**AccurIC Ltd second submission to 14-BSTD-1 (Title 24, building code)**

**California Energy Commission 2014 Appliance Efficiency pre-ruling**  
**Comments of AccurIC Ltd, via docket number 14-AAER-1 in relation**  
**to the proposed Voluntary California Quality LED Lamp**  
**Specification**

**Figure 1: Proposed maximum LED flicker mask, for limiting biological effects (currently under consideration by IEEE Working Group PAR1789)**

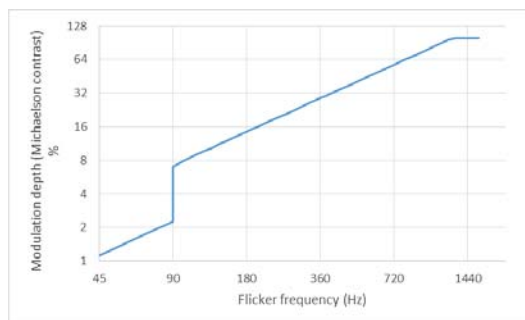
We strongly suggest, in order for a flicker performance related standard for LED lighting in the state of California to be aligned with emerging recommendations, based on peer-

reviewed research, that the maximum flicker mask shown in Figure 1 should be used as the basis for such a standard.

**Figure 3: The construction of Low Pass Filter bands which, when used additively (see Table 1) provide a stepwise approximation (red line) to the draft IEEE PAR1789 maximum flicker mask**

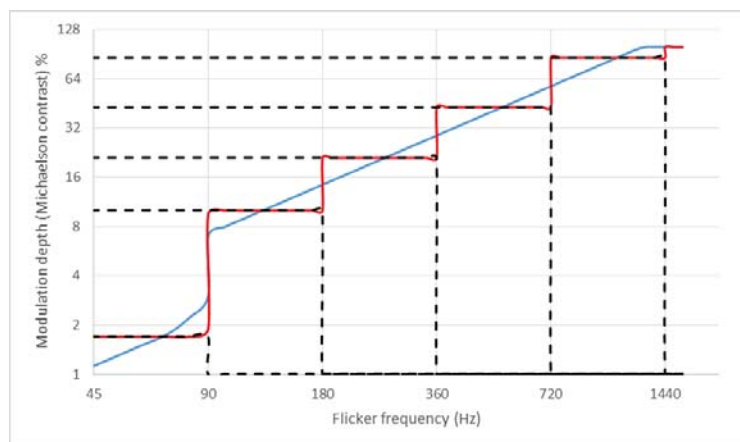
By choosing the cut-off frequencies of the low pass filters used in step 3(b) to be 90, 180, 360, 720 and 1440 Hz and defining appropriate maximum levels of modulation depth for each filter band, a stepwise approximation to the mask shown in figure 1 can be constructed. Figure 3 shows the low pass filter bands (shown as dotted lines) and the stepwise approximation to the mask (shown in red). The resulting flicker performance criteria, all of which need to be met in order to provide a sufficiently low flicker performance across all flicker frequencies, are summarised in Table 1.

**Note:** In order to ensure alignment with the proposed dimmability specification, the maximum flicker (modulation depth) criteria given in Table 1 should be met at the following dimming levels: 100% (undimmed) 50%, 20% and 10%
